BUELL

BYTES

ISSUE #7

JUNE 1997

FRONT BRAKE CALIPER SHIMMING

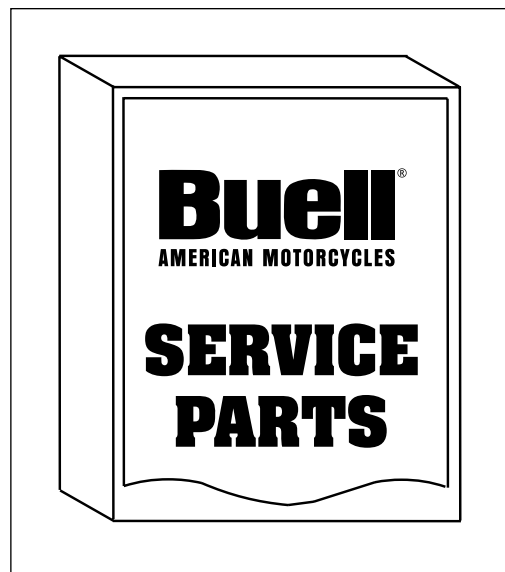
Some 1997 vehicles were built with shims placed between the two front brake caliper and fork leg mounting bosses. This is being done, in production, to properly position the caliper over the brake rotor.

If you are servicing a vehicle or installing replacement parts, it is important that the original shims be reinstalled or new shims installed as necessary. Failure to correctly shim calipers could result in component wear or personal injury. The kit, part number 44001-97Y contains six shims, two of each size (0.16", 0.32" & 0.62"), in a package.

At each mounting boss use a combination of shims as needed to center the brake pads equally over the rotor.

page 16
pages 2-35/37

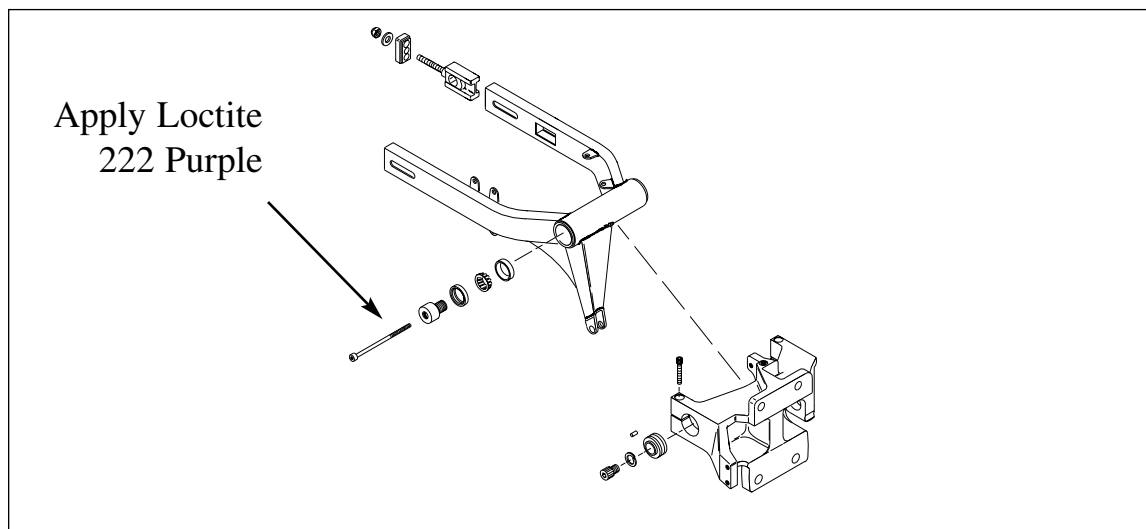
Changes have been made to 1997 swingarms to provide for easier bearing adjustment and preload. The adjusting bolt preload has been revised to 2.75-3.75 lbs. Loctite 222 Purple is now recommended for the bolt's threads. Please note these changes to the following Service Manual pages:

1997 M2 SERVICE MANUAL UPDATE

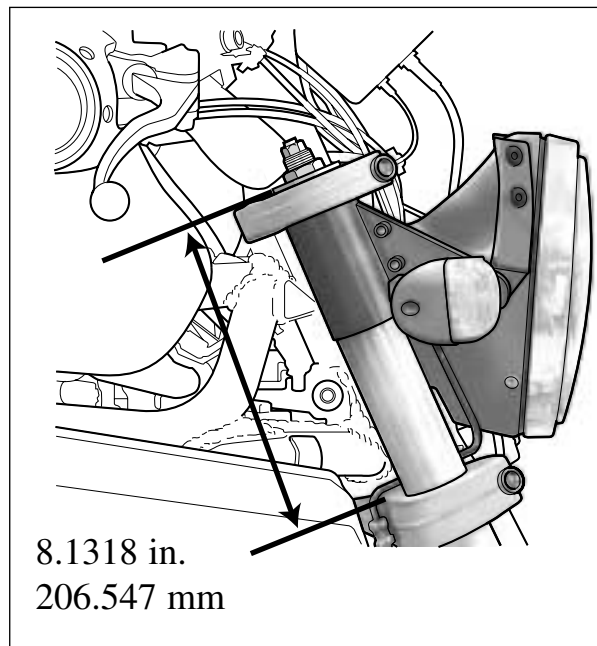
Please note a correction to the artwork illustrating the front fork installed height for the M2 Cyclone front fork tubes. The manual artwork on page 2-33 incorrectly illustrates the installed height of the front fork tubes. The specification given is correct, however the fork tube should be installed with the fork cap level with the upper triple tree. The illustration shown here gives the corrected location.
